LOTS 1 thru 7 and OPEN SPACE LOT 8

SUPPLEMENTAL PLANS

A RESUBDIVISION OF CEDAR ACRES BLOCK A, LOT 12 PLAT BOOK 4, FOLIO 11, 10932 HILLTOP LANE TAX MAP: 35 - GRID: 11 - PARCEL: 41 ZONED: R-SC

TITLE SHEET APRIL 16, 2018 BEI PROJECT NO. 2615

CHIEF, DEVELOPMENT ENGINEERING DIVISION

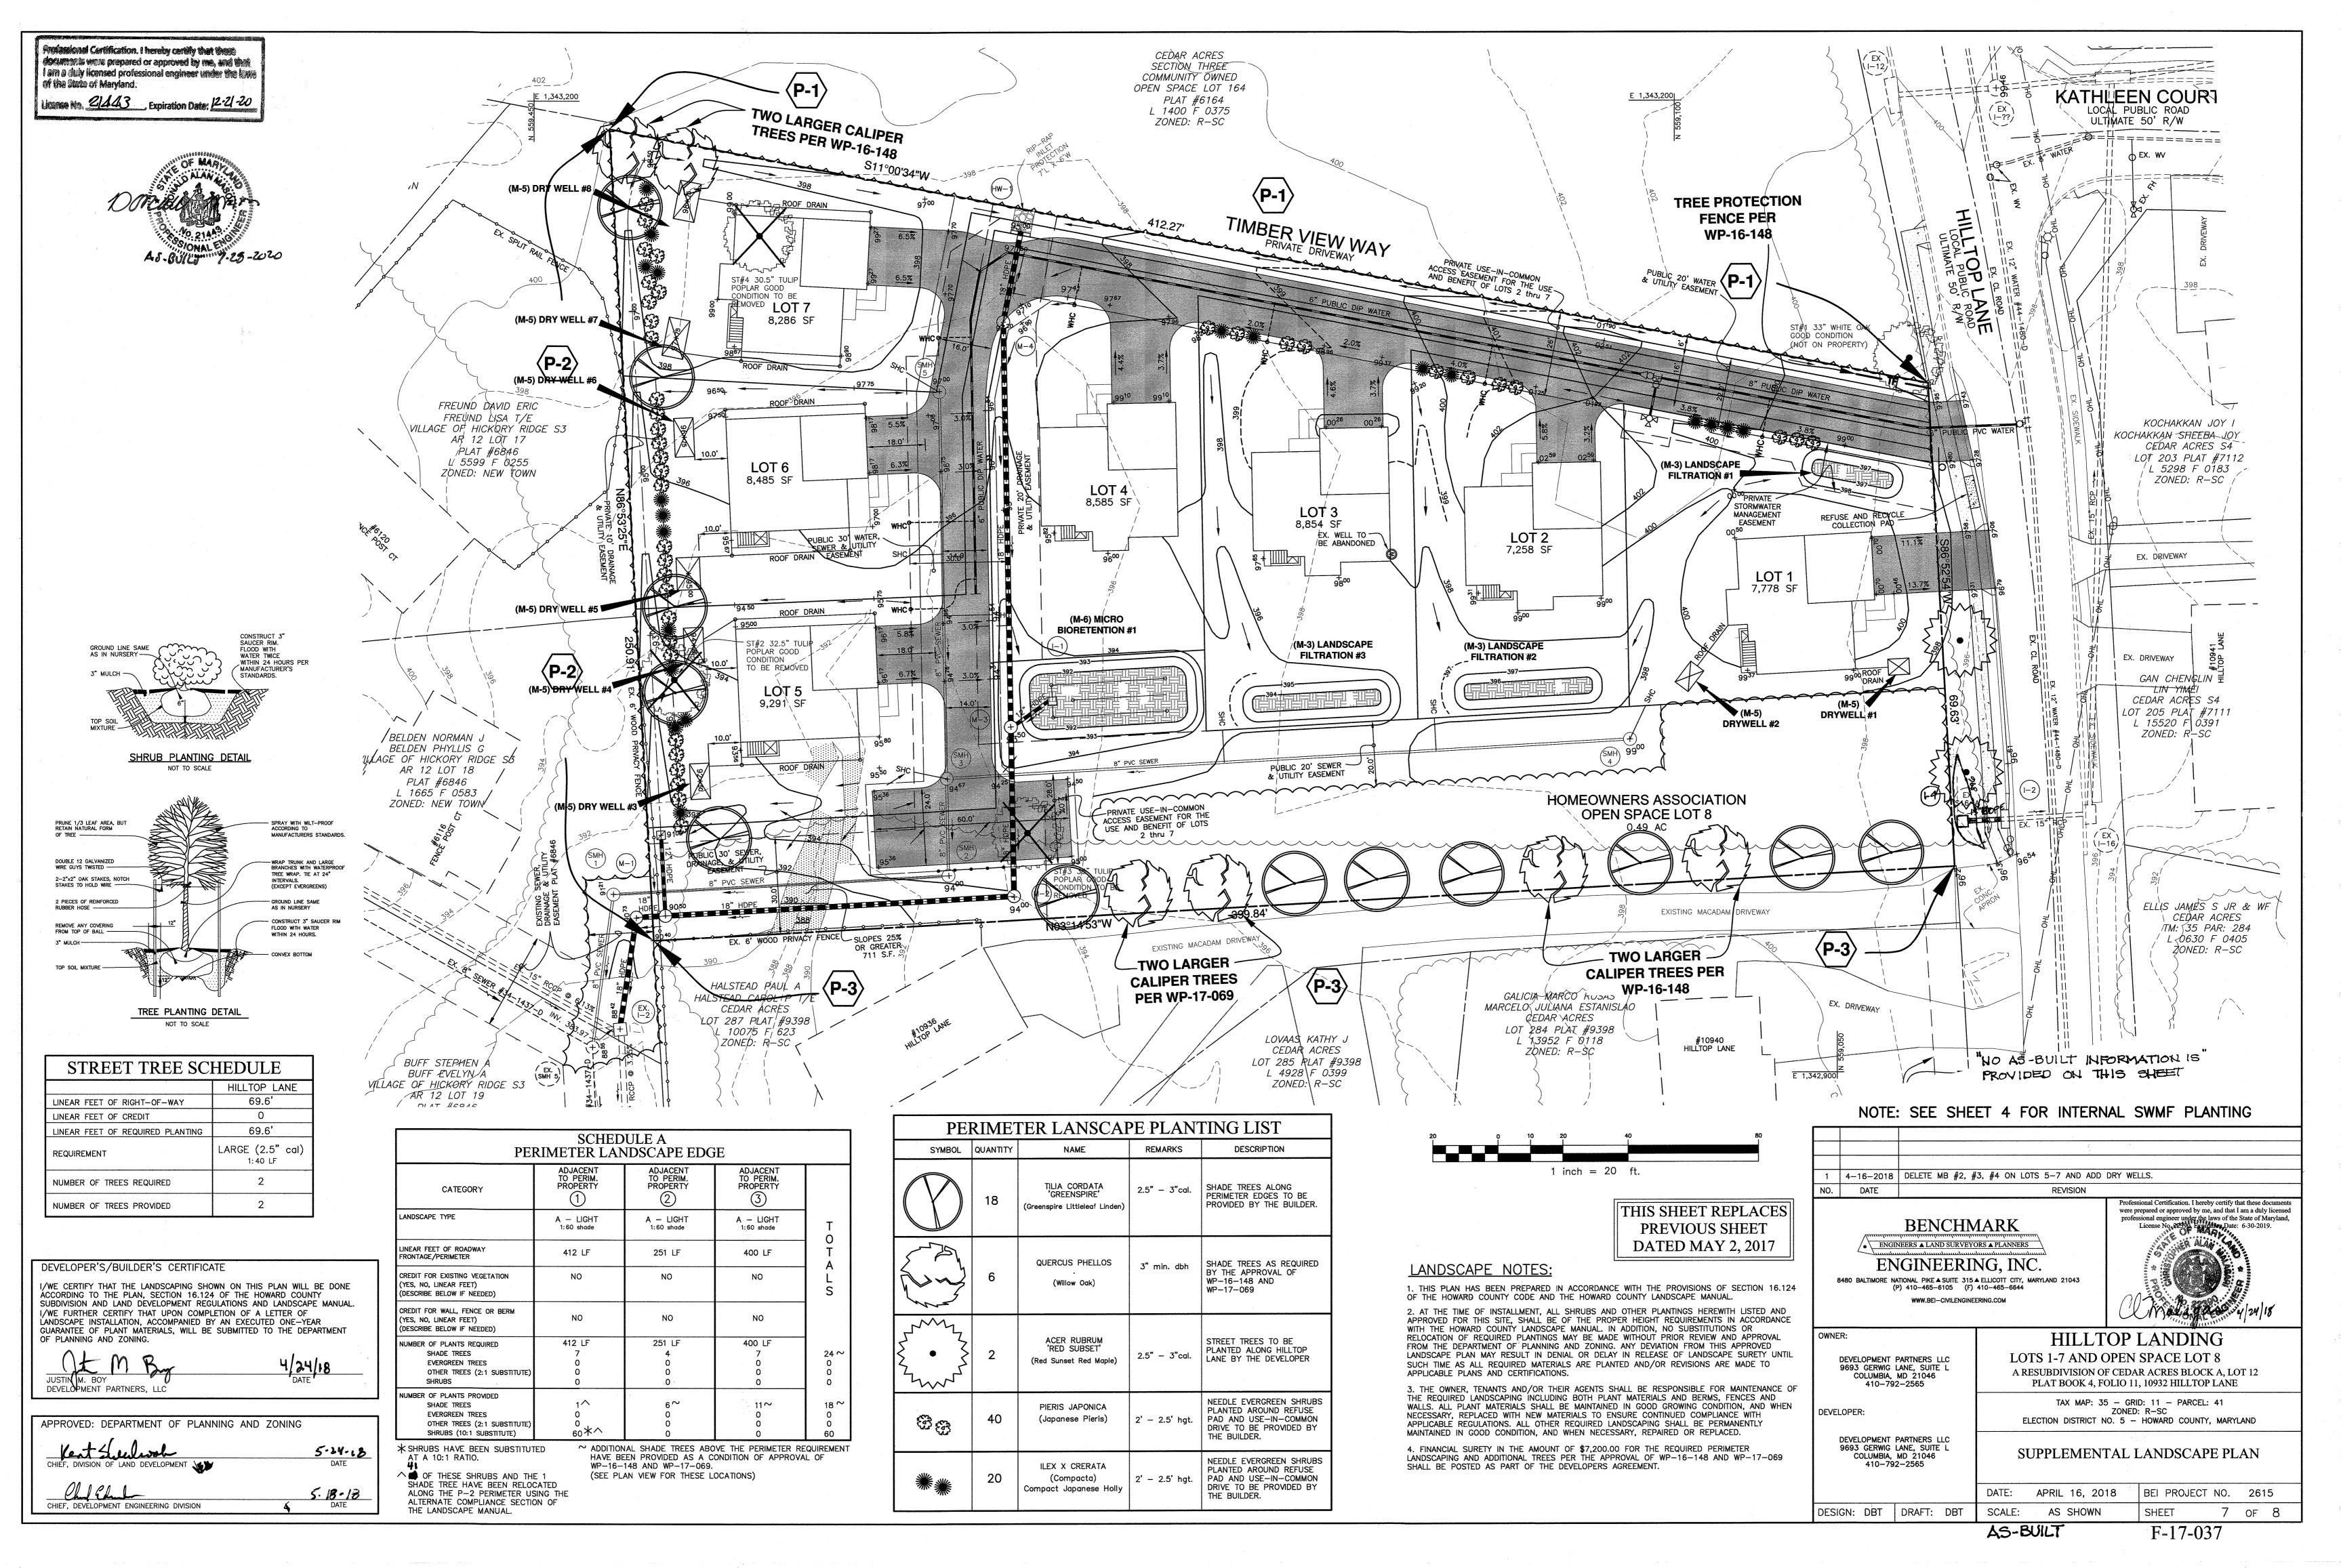
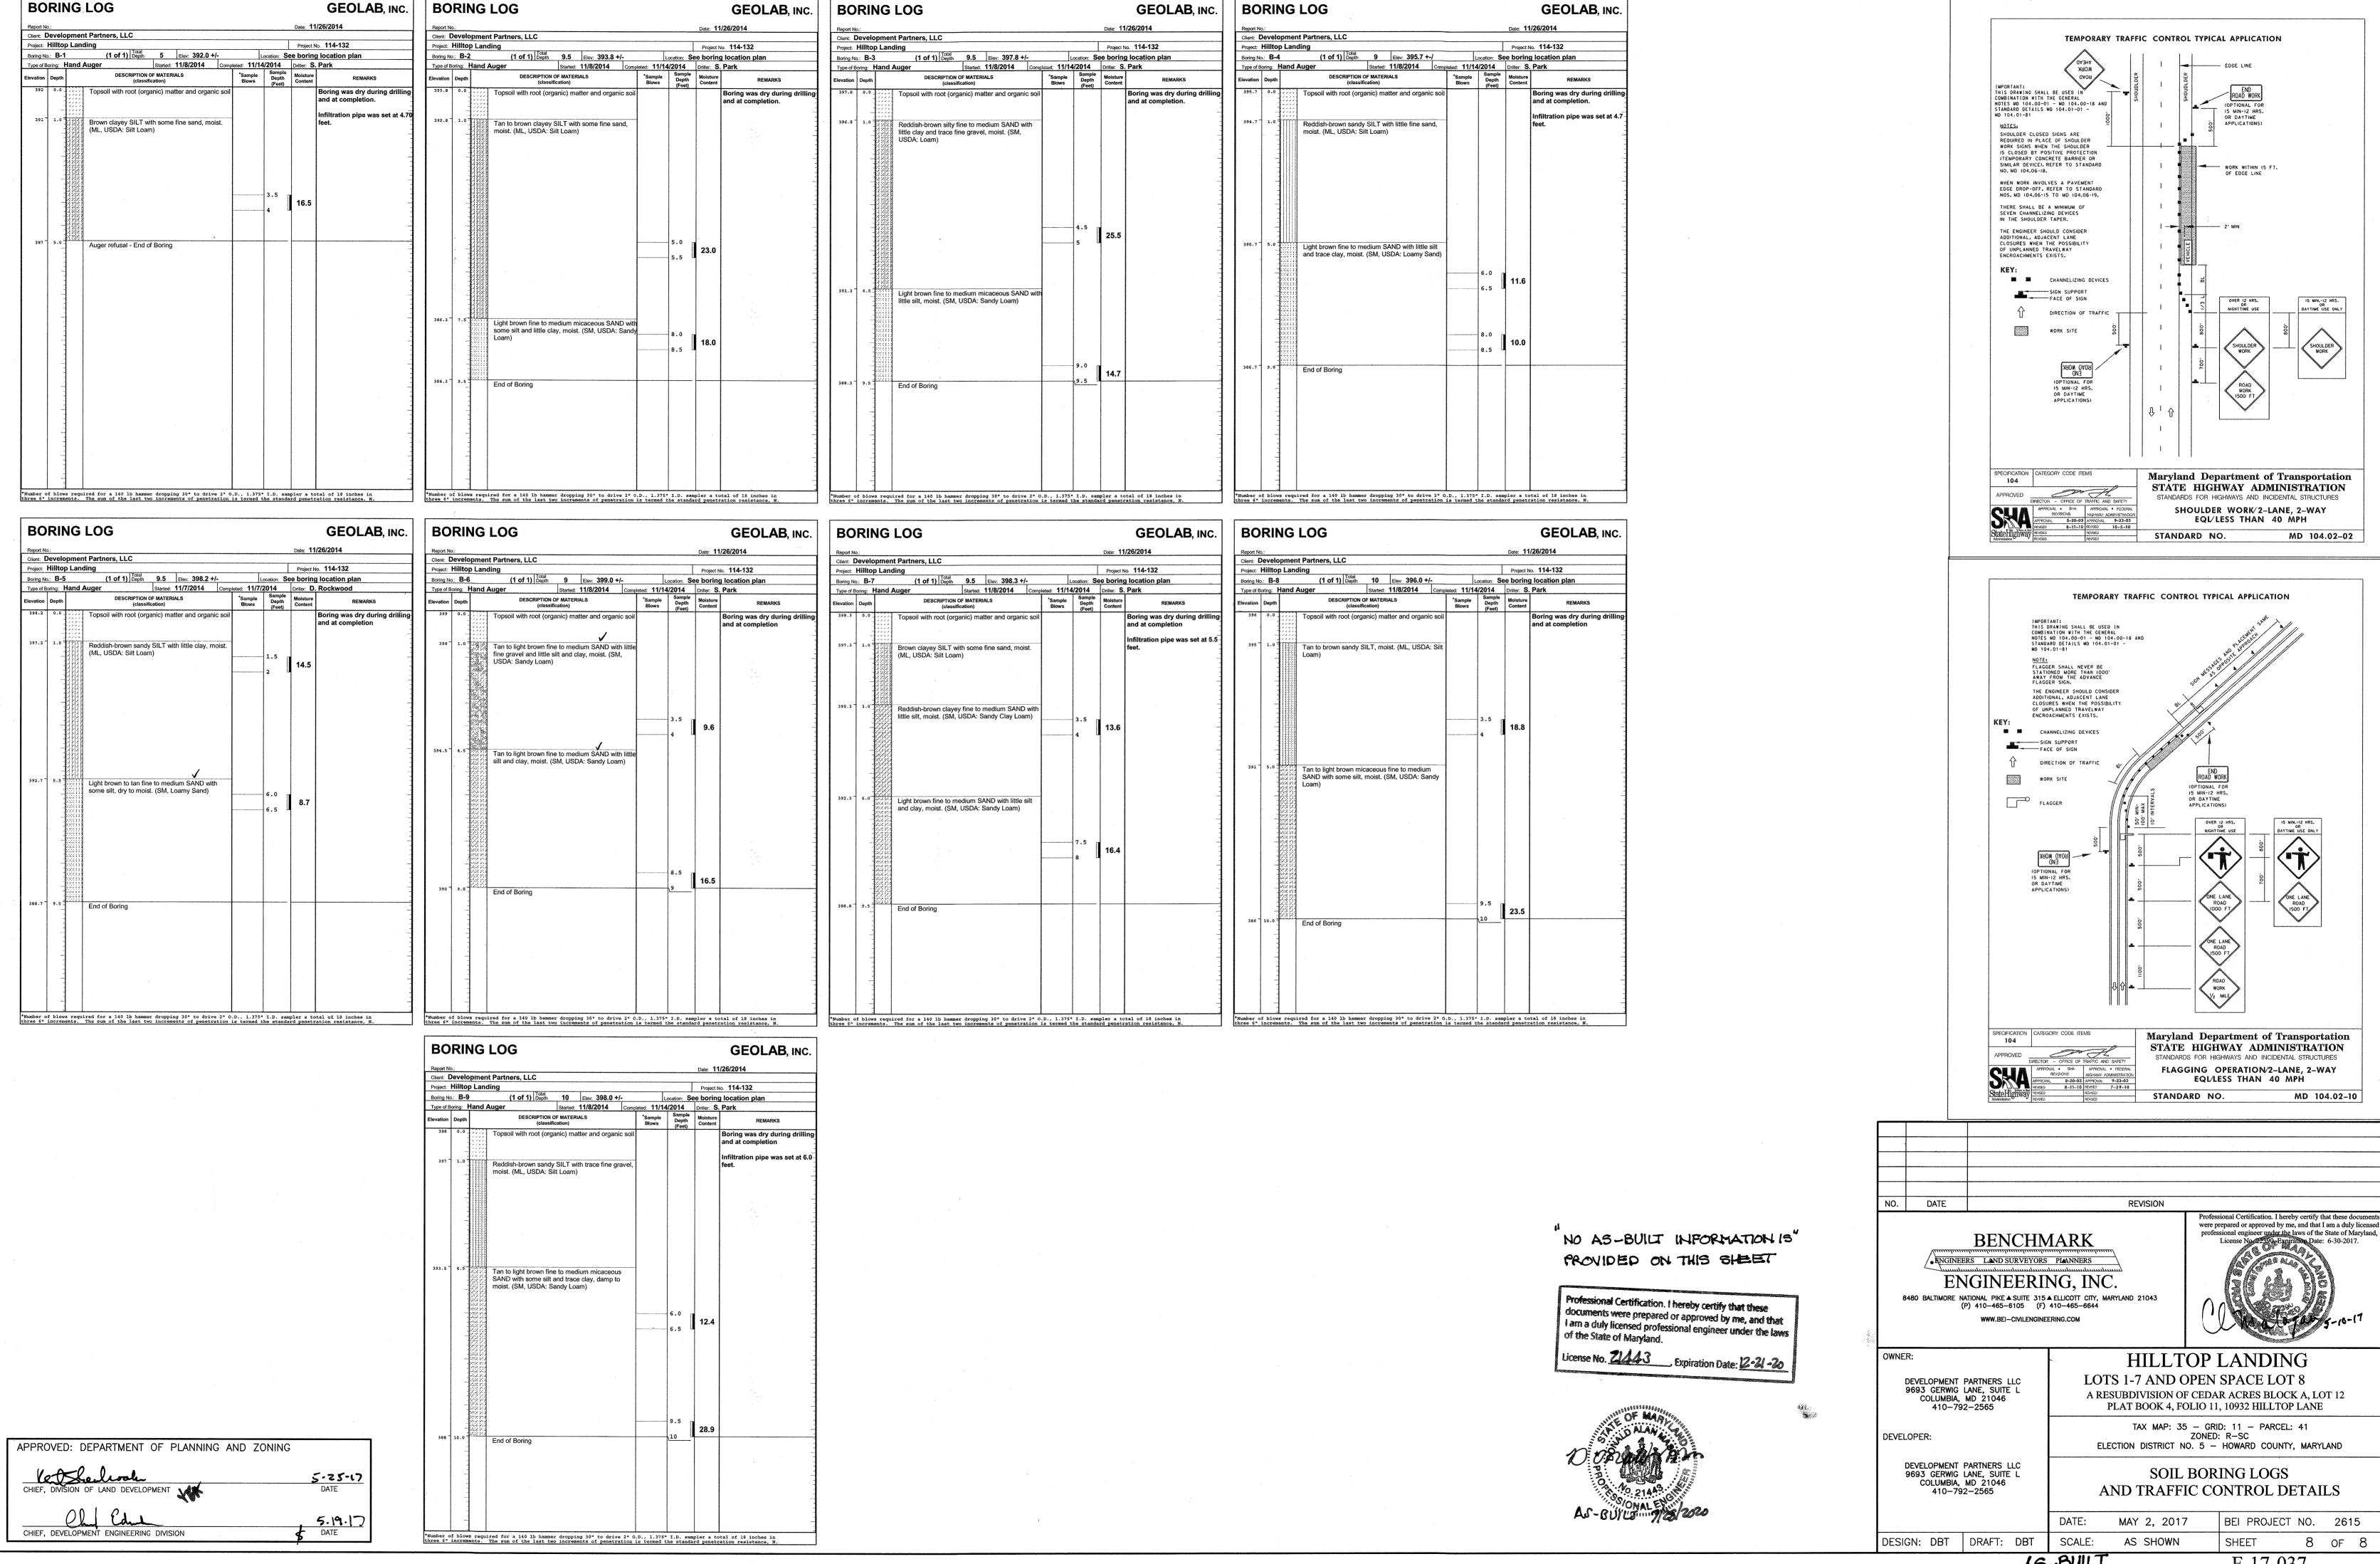
K IHODE MID			1101 10 00/12					
my knowledge .T"	1	4-16-2018	REMOVE MB #2, #ADD DRY WELLS #	#3, AND #4 FROM LANDSCAPE C #3-#8 TO DRY WELL CHART	HART.			
)NS	NO.	DATE		REVISION				
Date: 7/28/2020	٤	ENGINE NA BALTIMORE NA	BENCHM WEERS & LAND SURVEYOR  TOTAL PIKE & SUITE 315 A P) 410–465–6105 (F)  WWW.BEI-CIVILENGINE	DRS A PLANNERS  Administration of the state	Professional Certification. I hereby certify that these documents were prepared or approved by me, and that I am a duly licensed professional engineer under the laws of the State of Maryland, License No. 2390 Exprantion Date. 6-30-2019.			
aat aws 2a		R: DEVELOPMENT F 9693 GERWIG L COLUMBIA, I 410-792	ANE, SUITE L MD 21046	HILLTOP LANDING LOTS 1-7 AND OPEN SPACE LOT 8 A RESUBDIVISION OF CEDAR ACRES BLOCK A, LOT PLAT BOOK 4, FOLIO 11, 10932 HILLTOP LANE
